Addendum No. 1

Project No: 22132

Project: **Proposed Mixed-Use Building 510 & 520 Taunton Rd E**
GAY COMPANY LIMITED

The following information supplements and/or supersedes the bid documents issued on September 28, 2026

1 S202 TYPICAL 3rd TO 4th FLOOR FRAMING PLAN
1 : 100

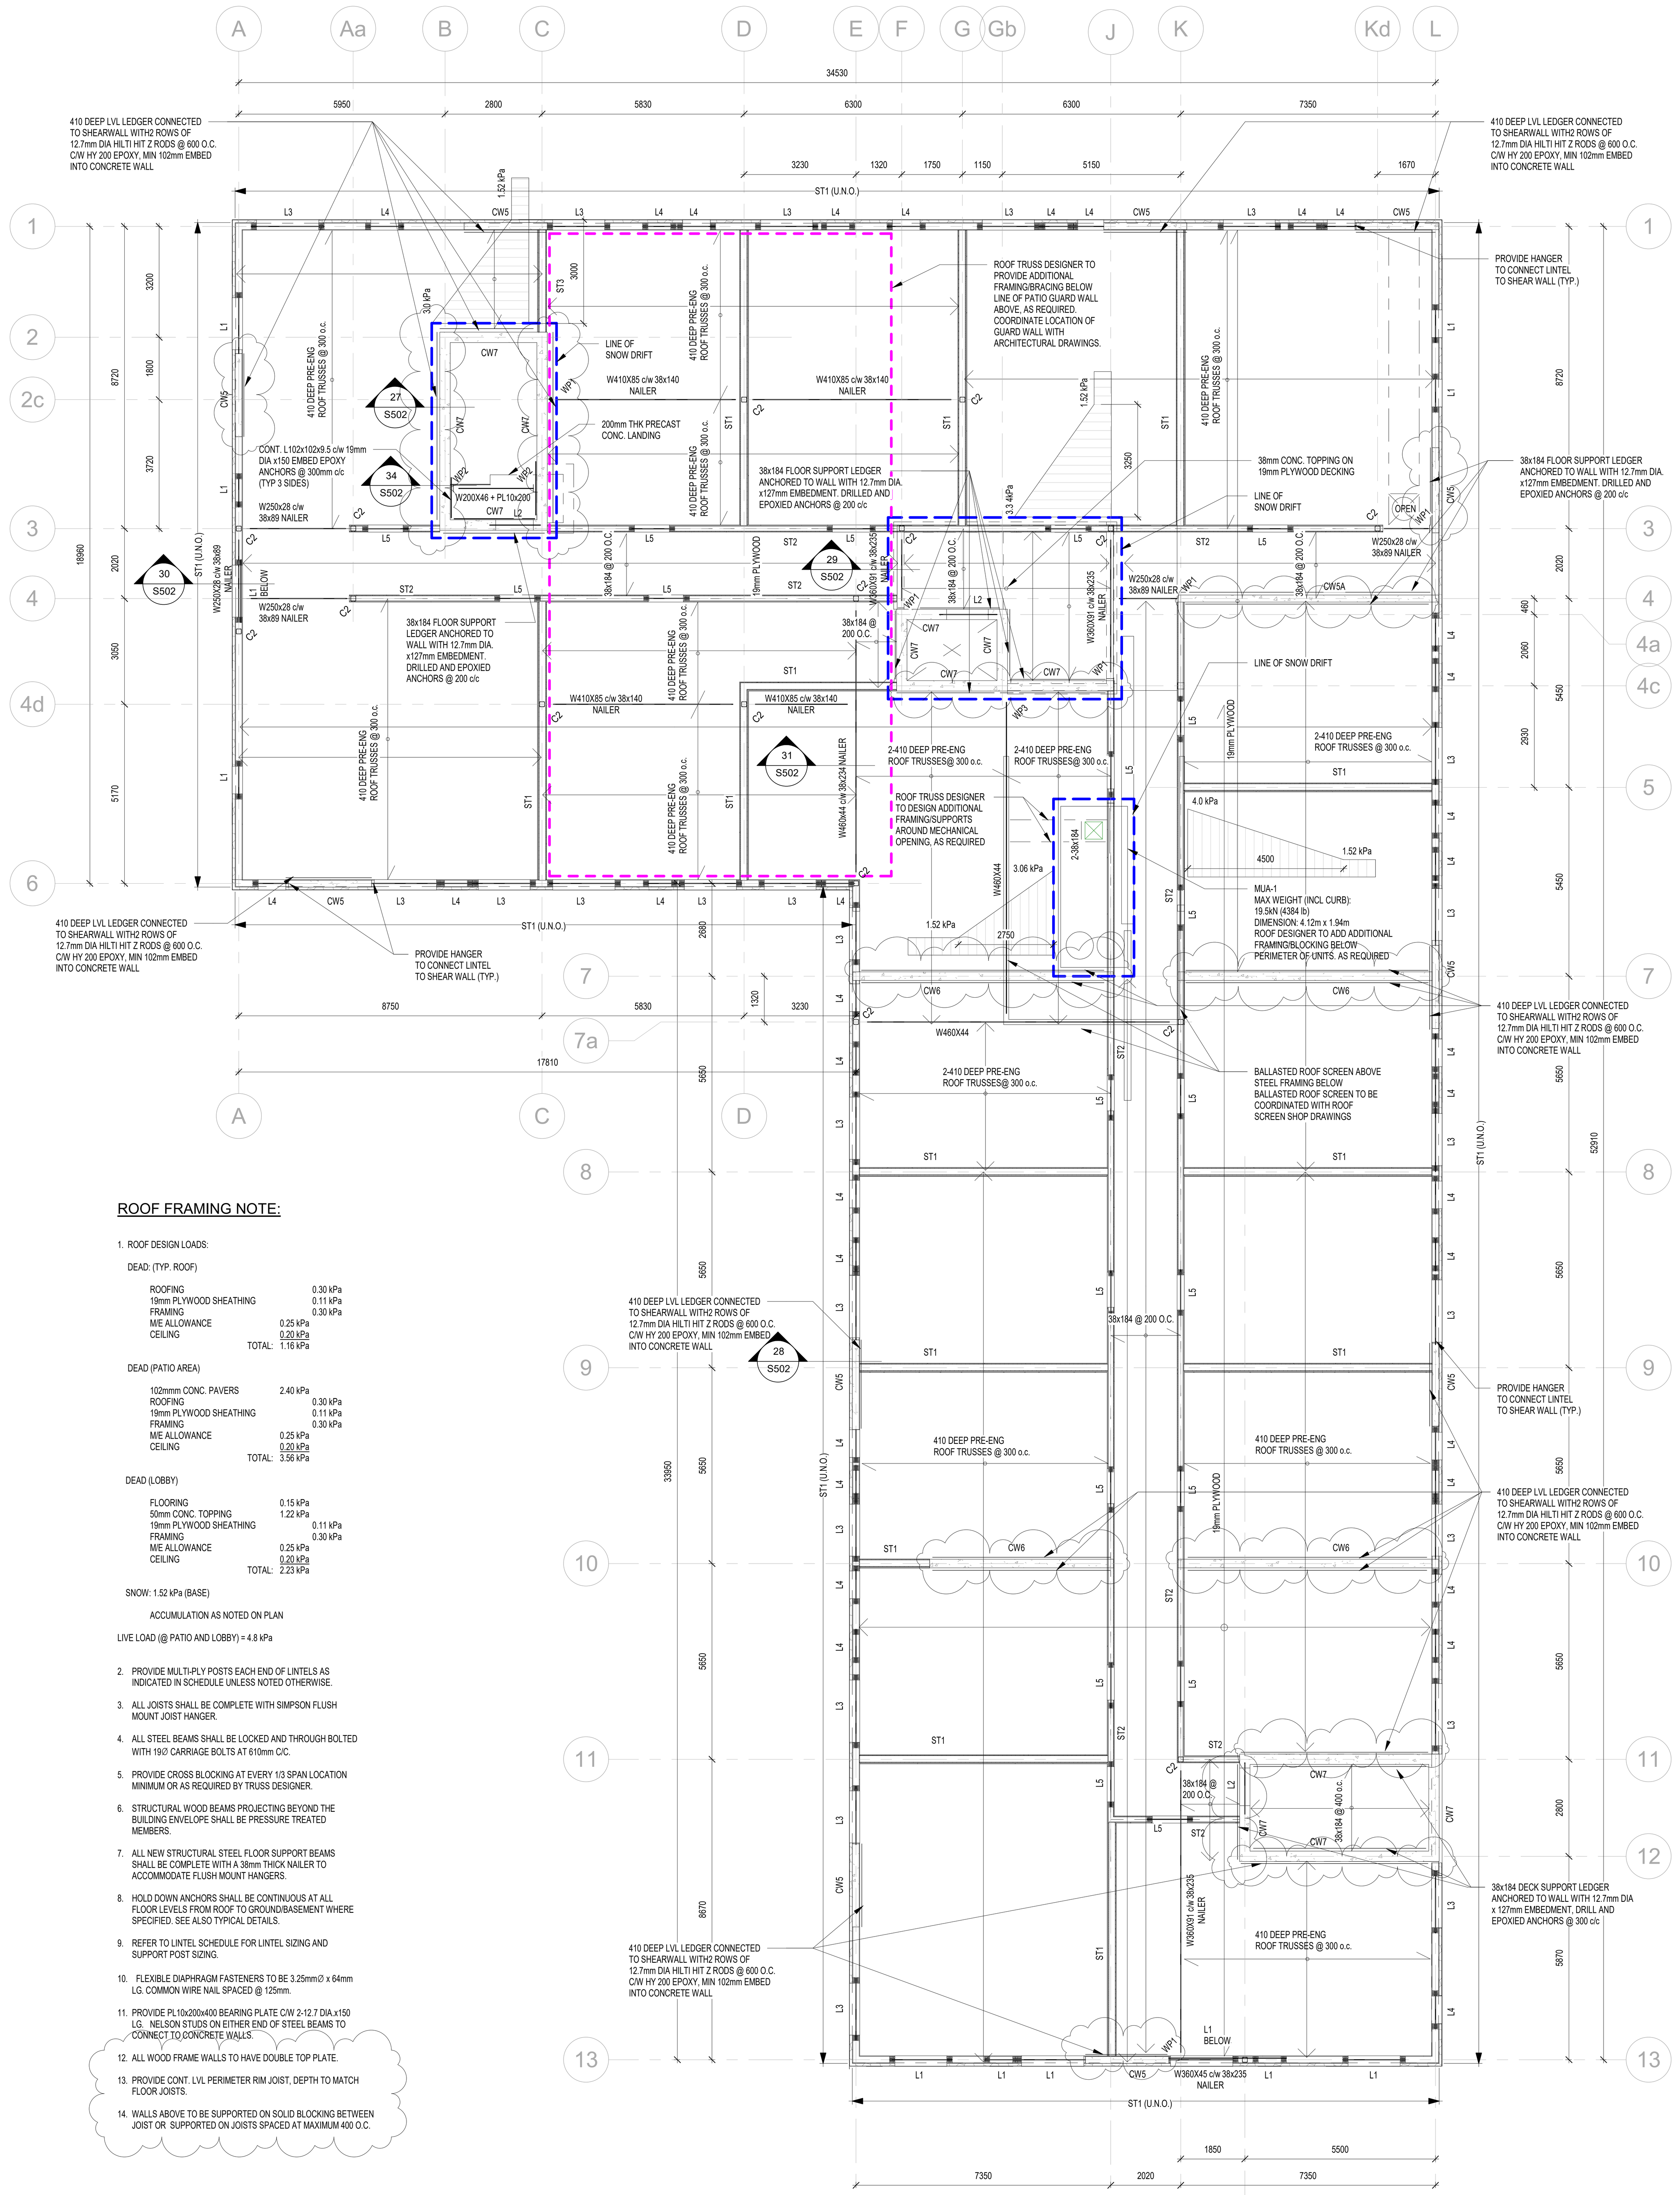
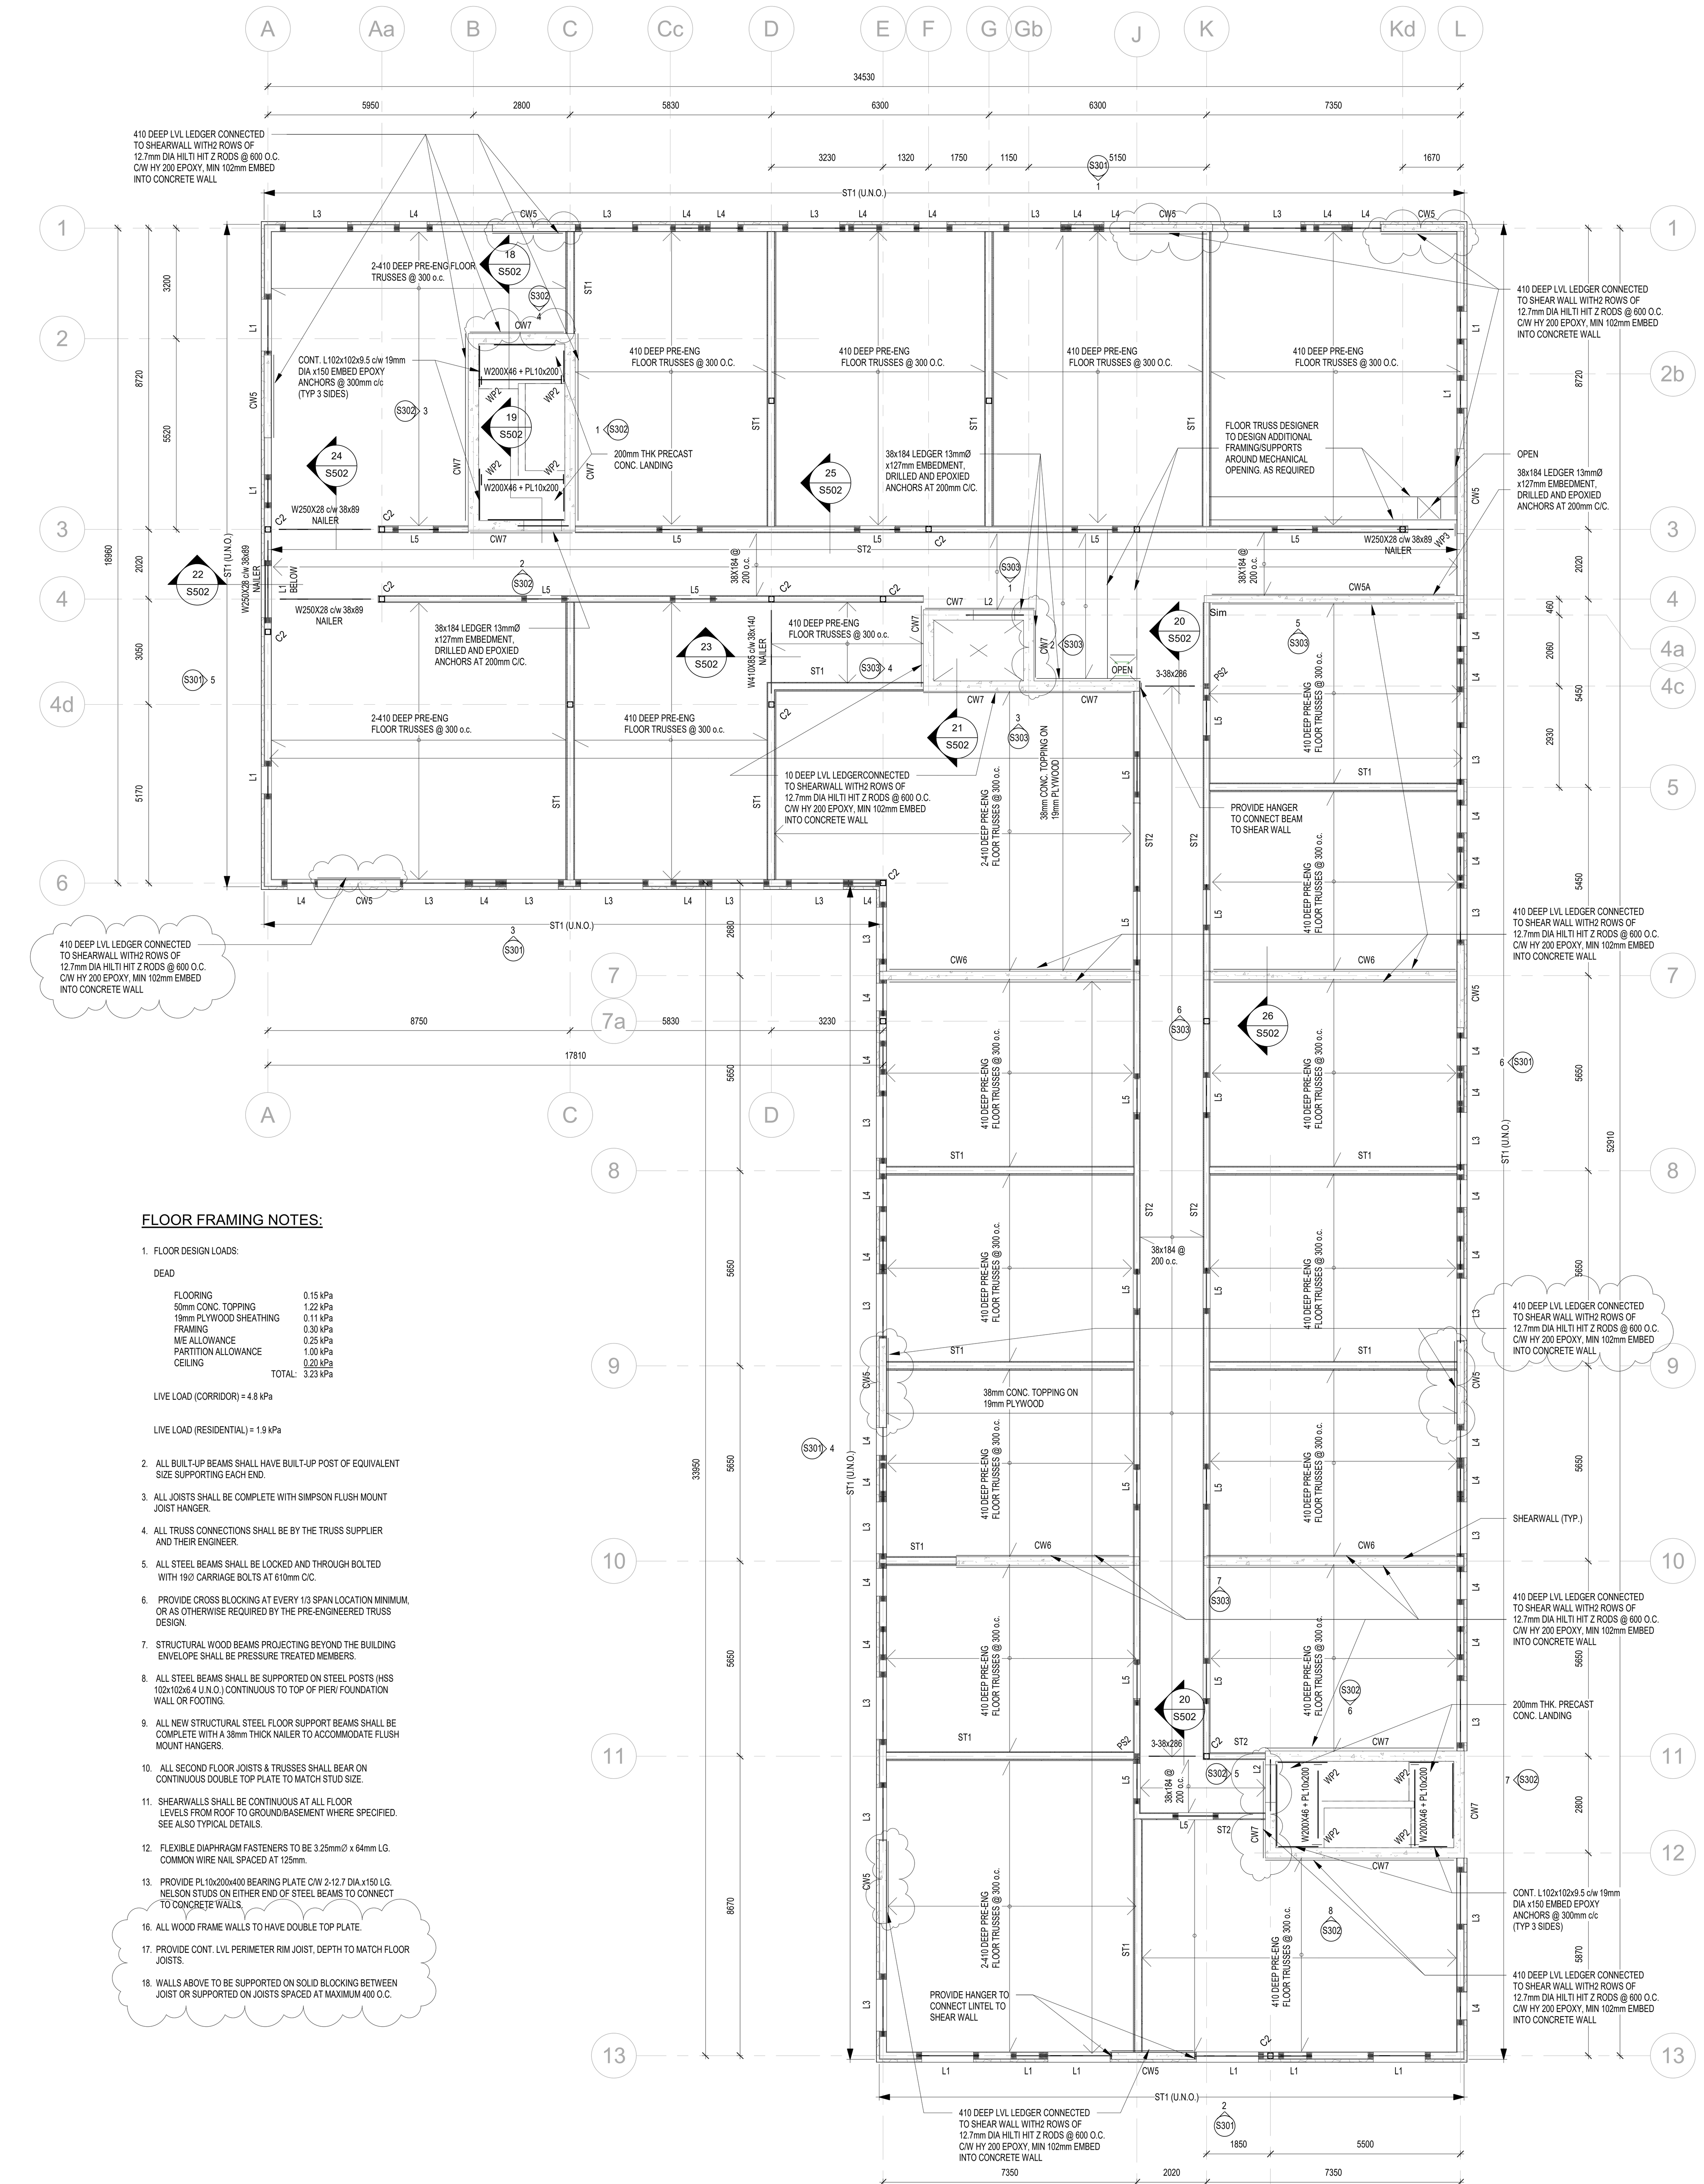
.1 Notes 16-18 added under FLOOR FRAMING NOTES, 1/S202.
.2 Notes 12-14 added under ROOF FRAMING NOTES, 2/S202.
.3 Roof plan and floor plans updated to show ledgers along concrete shearwalls. See 1/S202 and 2/S202.

16. ALL WOOD FRAME WALLS TO HAVE DOUBLE TOP PLATE.
17. PROVIDE CONT. LVL PERIMETER RIM JOIST, DEPTH TO MATCH FLOOR JOISTS.
18. WALLS ABOVE TO BE SUPPORTED ON SOLID BLOCKING BETWEEN JOIST OR SUPPORTED ON JOISTS SPACED AT MAXIMUM 400 O.C.

14 S501 SECTION 1 : 20

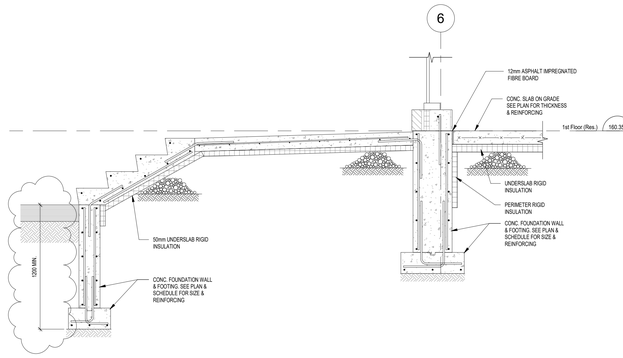
.1 Detail 14/S501 updated to indicate minimum depth of exterior footing.

DRAWING:
FRAMING SECTIONS

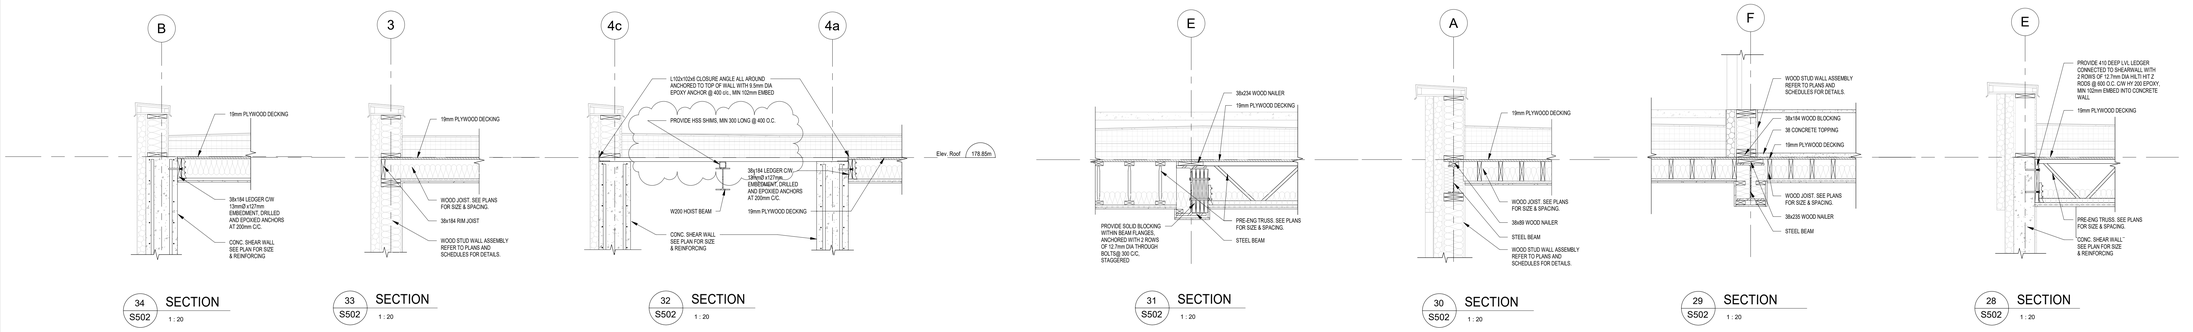
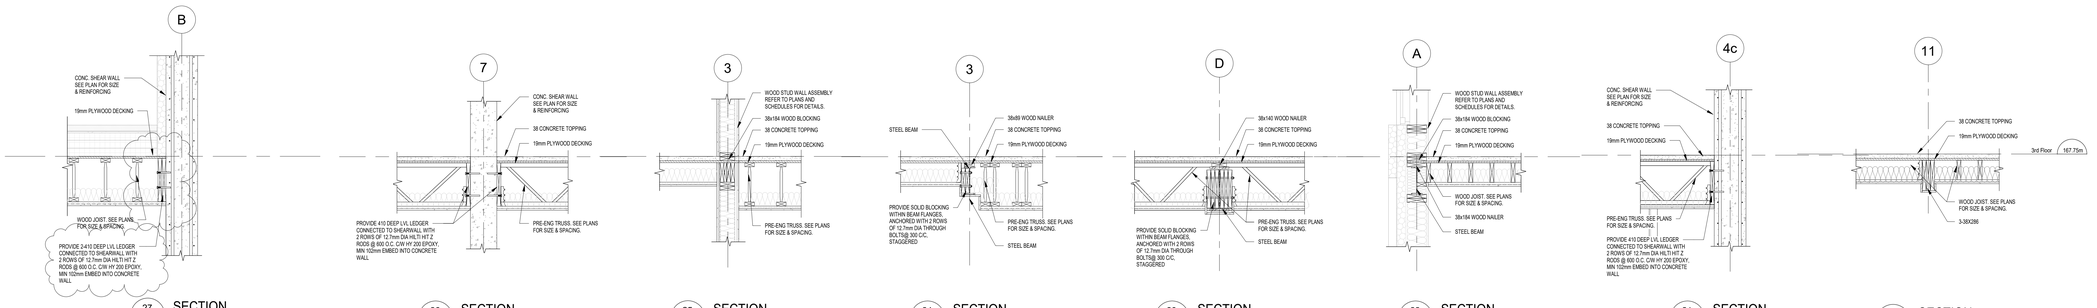
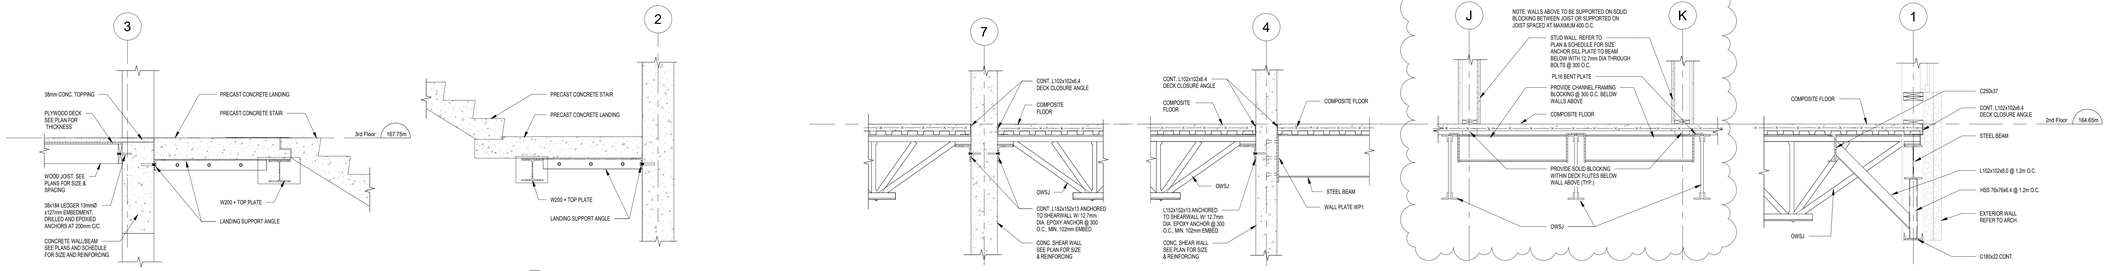
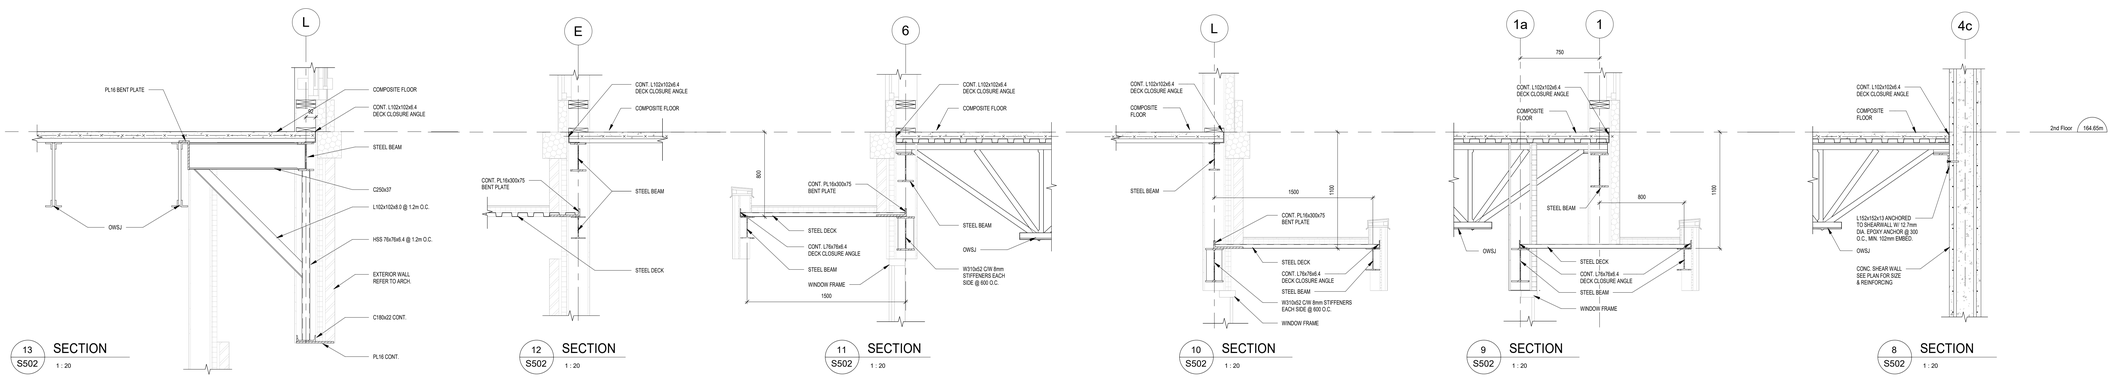
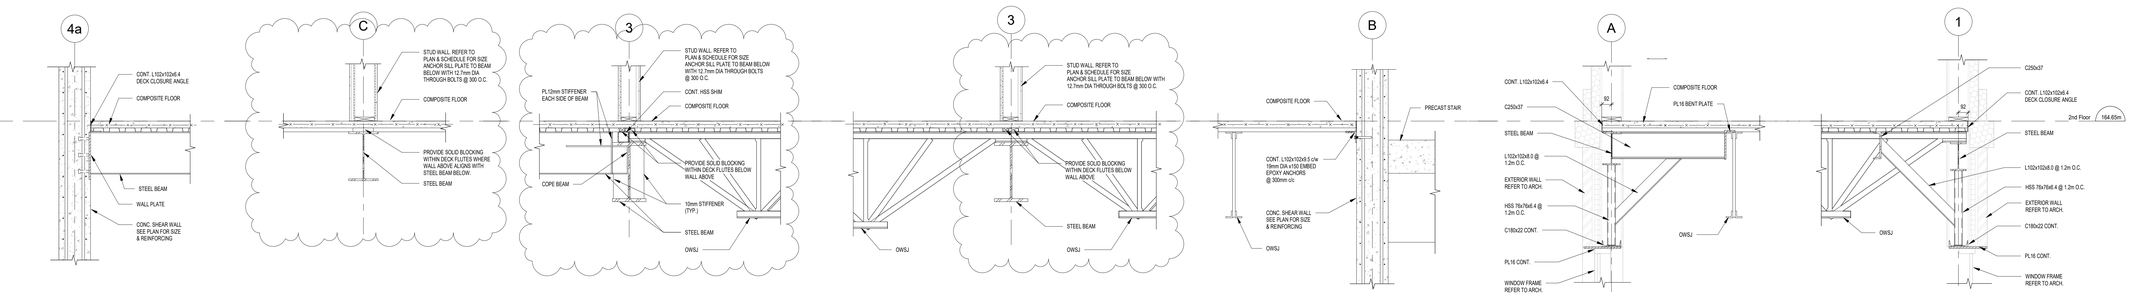
.1 Section 4, 5, and 6 updated to indicate blocking and wall anchoring requirements.
.2 Section 15 updated to indicate framing requirements below walls above, blocking, and wall anchoring details.
.3 Section 27 updated to indicate end joist anchoring to parallel concrete wall.
.4 Section 32 updated to include HSS shims between top of hoist beam and roof deck.
